**Addendum #1**  
**2020 Roadway Improvement Project**  
**“Cambridge Drive Neighborhood”**  
**Bid No. 20-15**  
**Town of East Hartford**

**February 28, 2020**

The following summarizes the revisions to the Bid Documents included in Addendum #1 for the 2020 Roadway Improvement Project (Bid No. 20-15).

SHEET NO.:  
**079 OF 294**

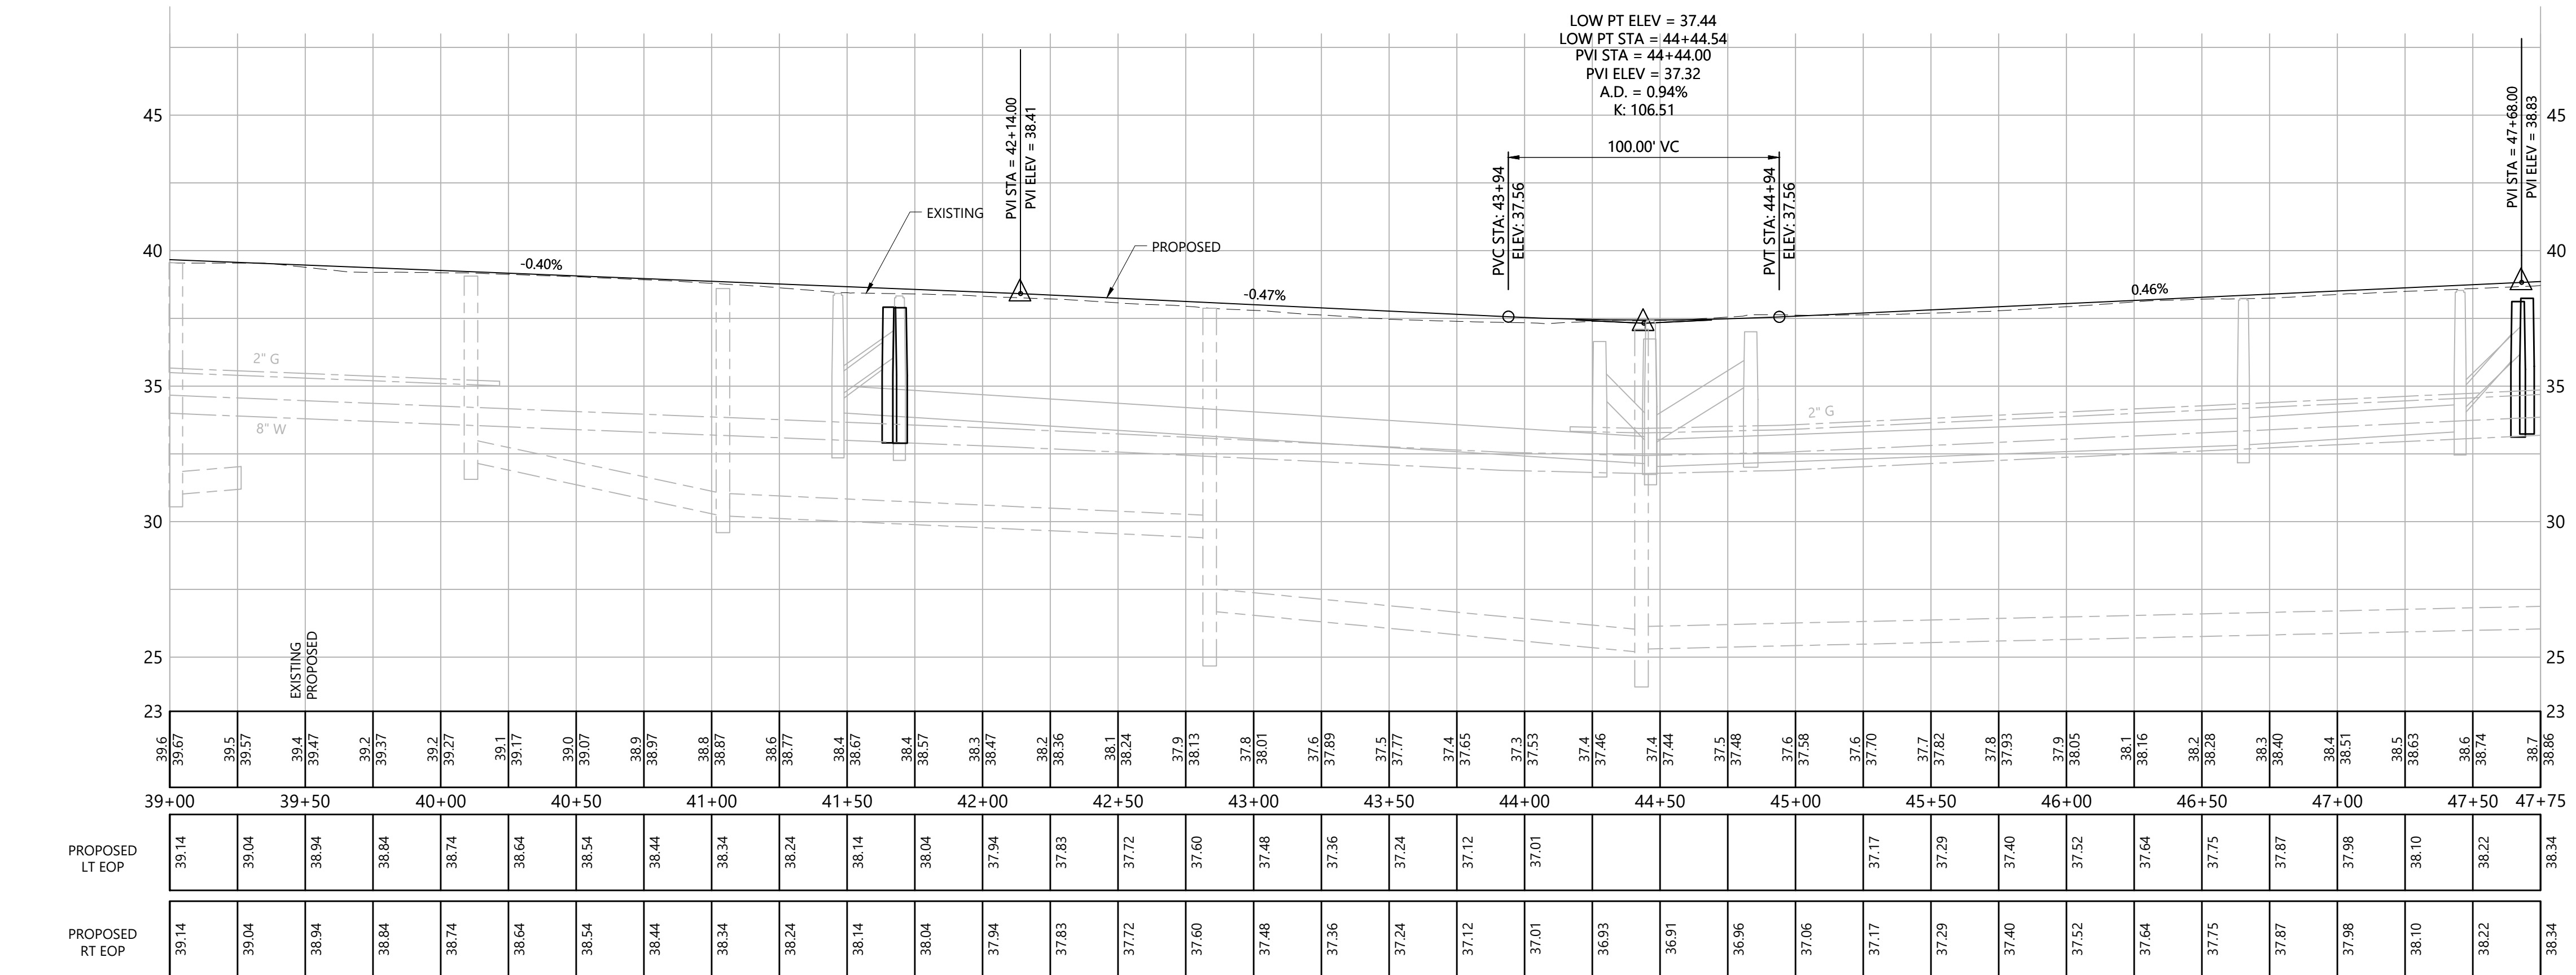
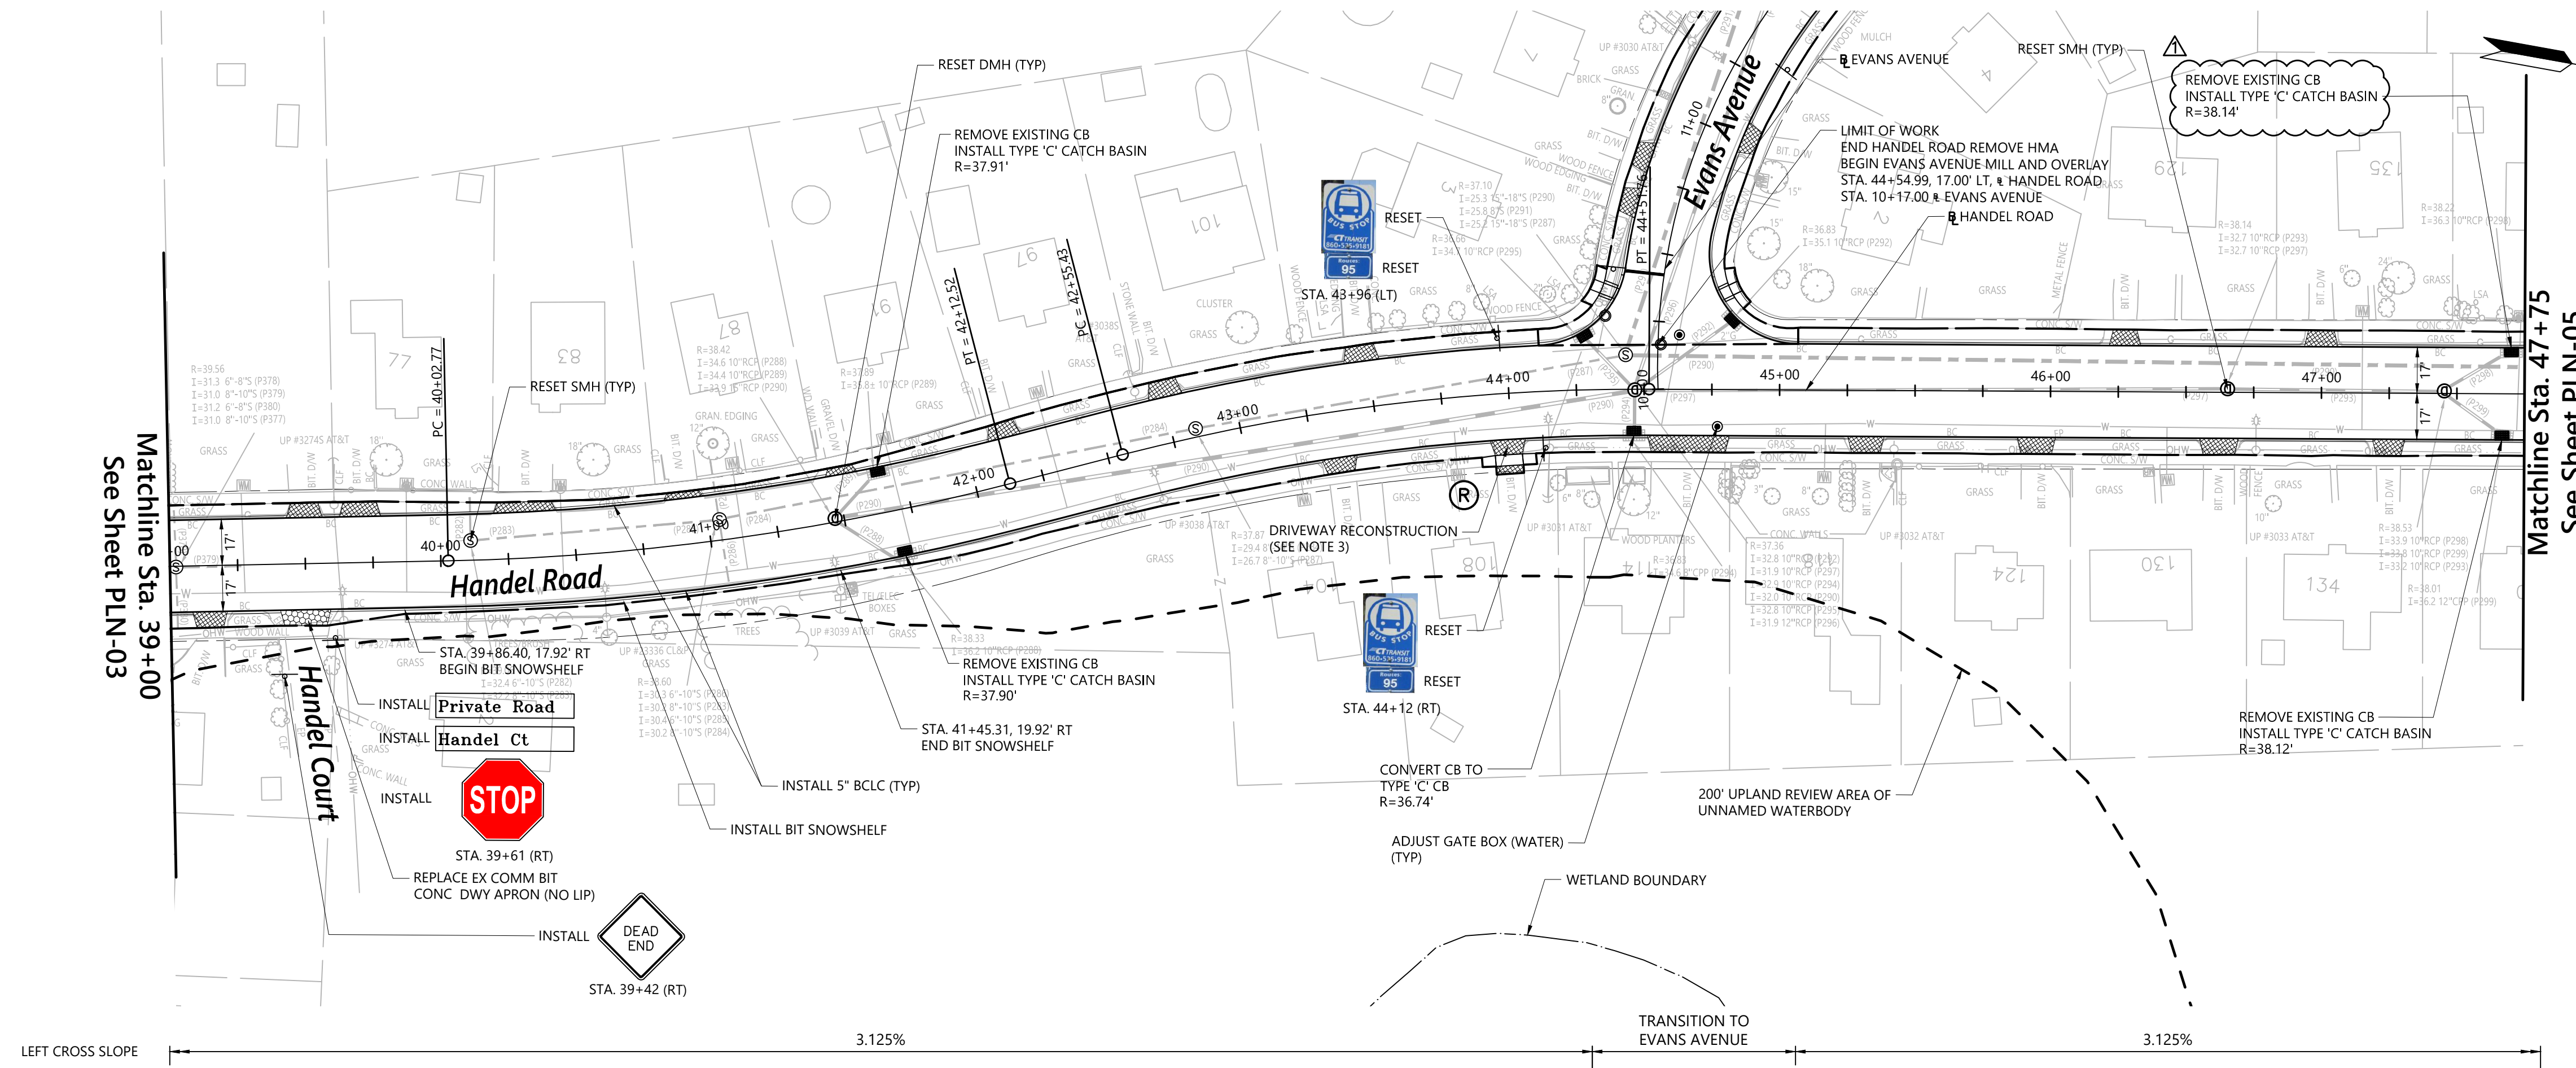
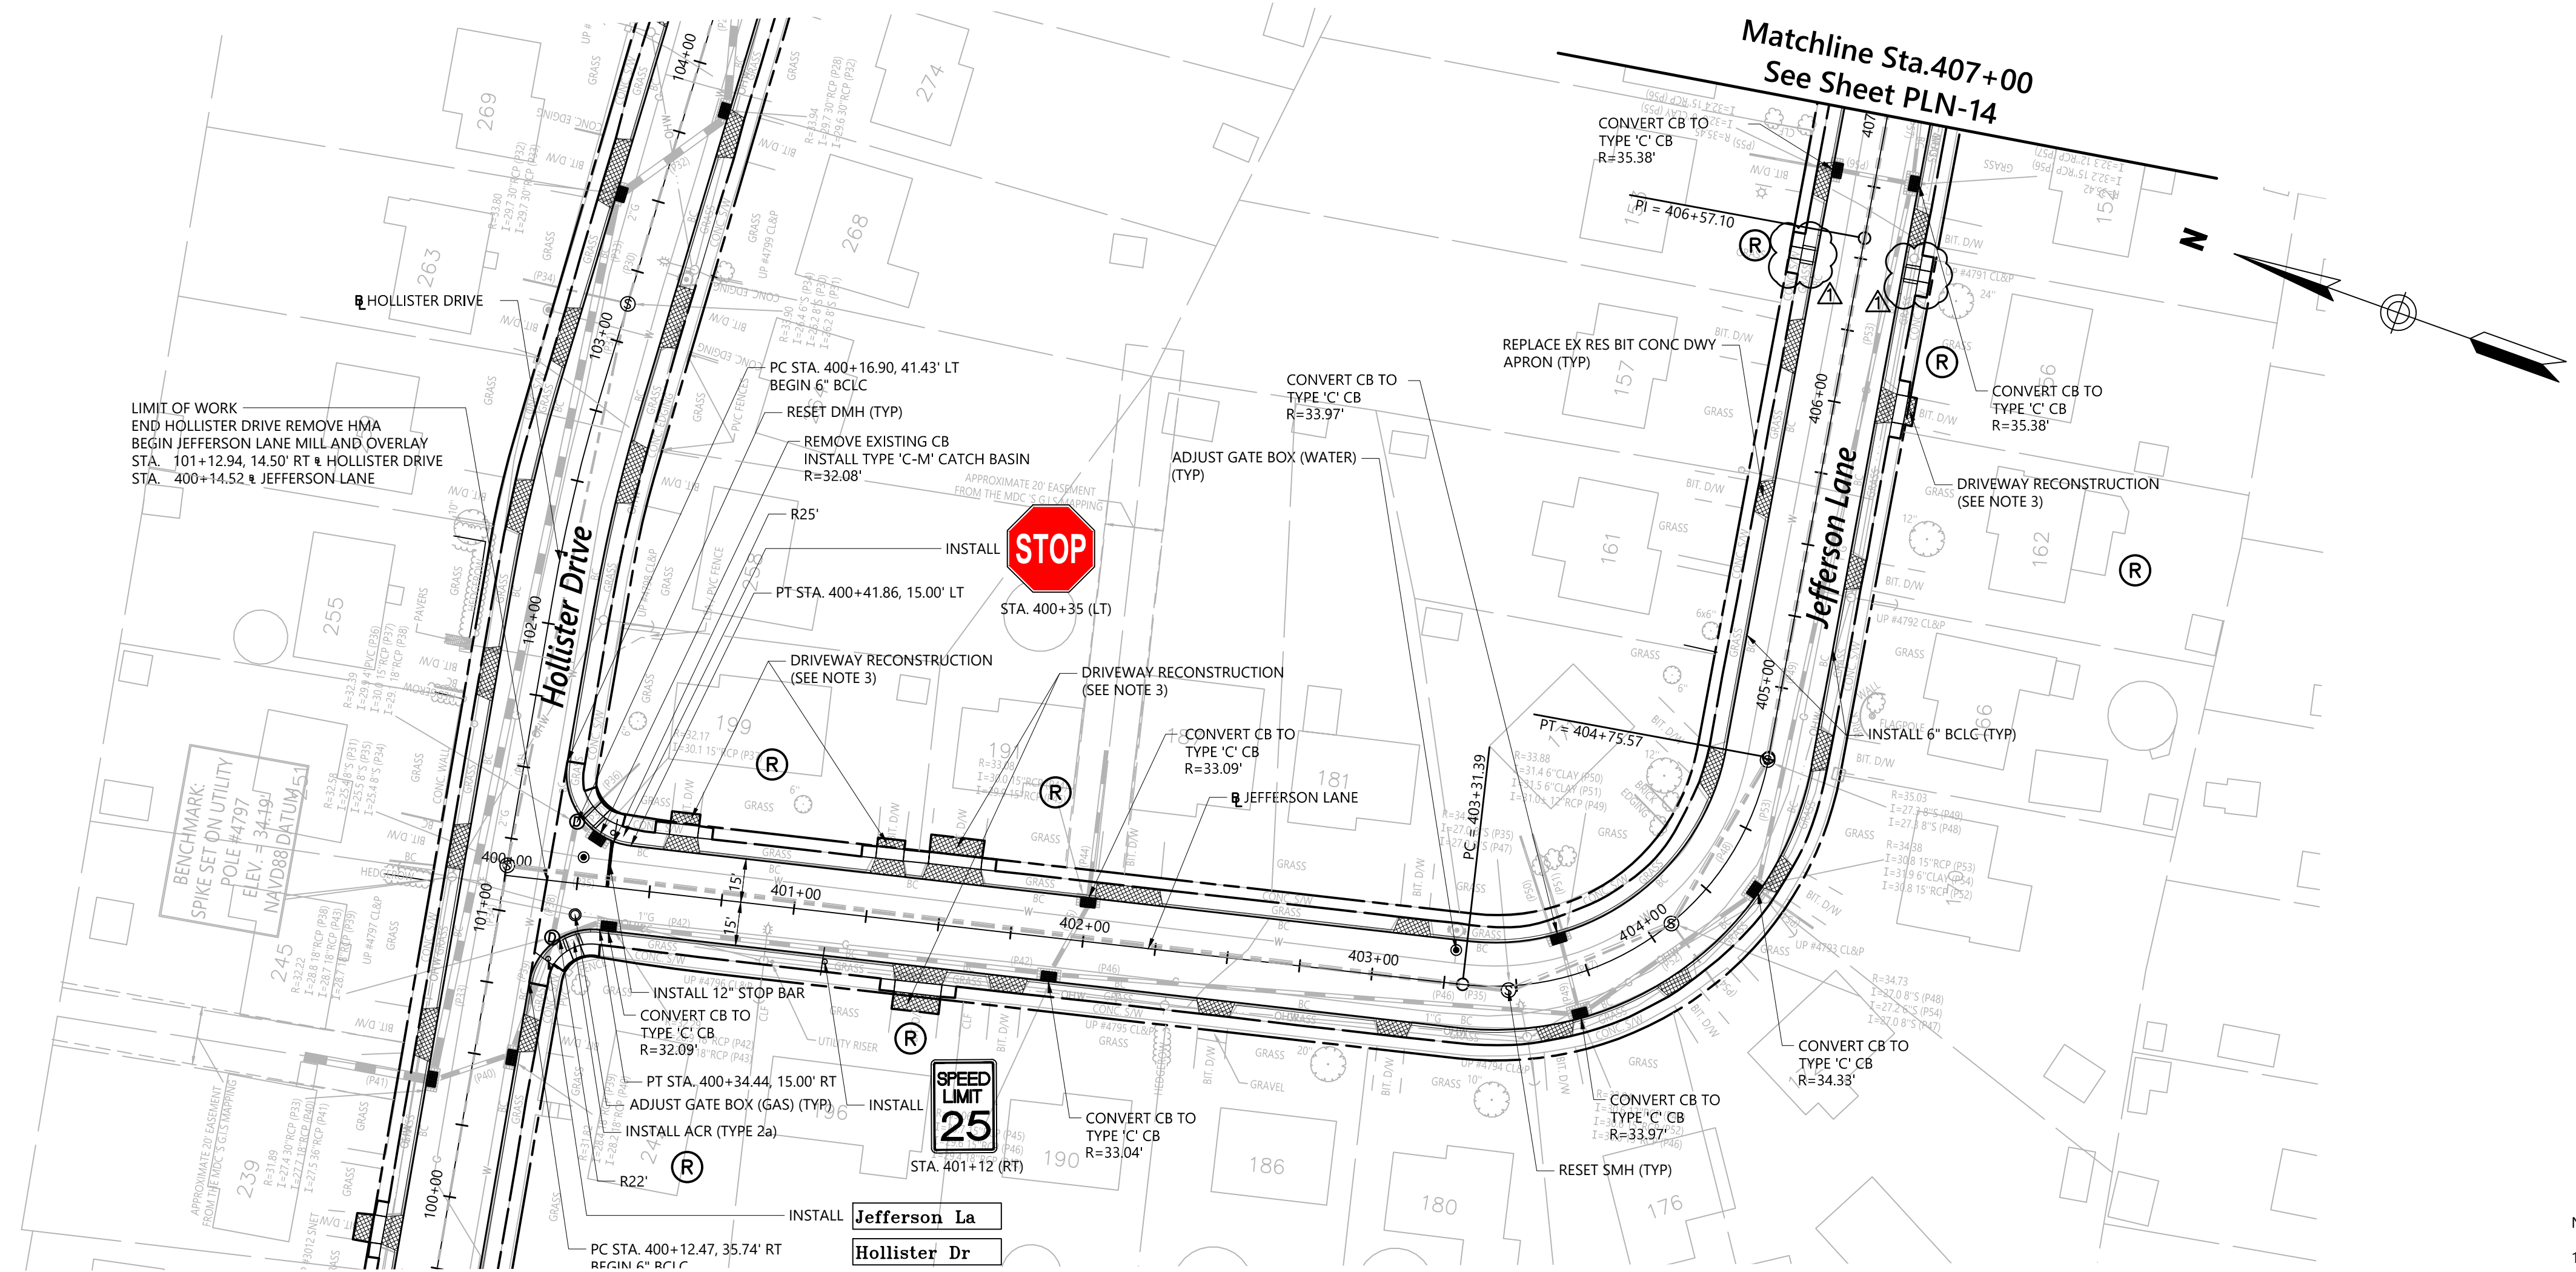
- Replace plan sheet 079 of 294 to reflect a revised rim elevation.

REV.	DATE	REVISED RIM ELEVATION	DESCRIPTION	079
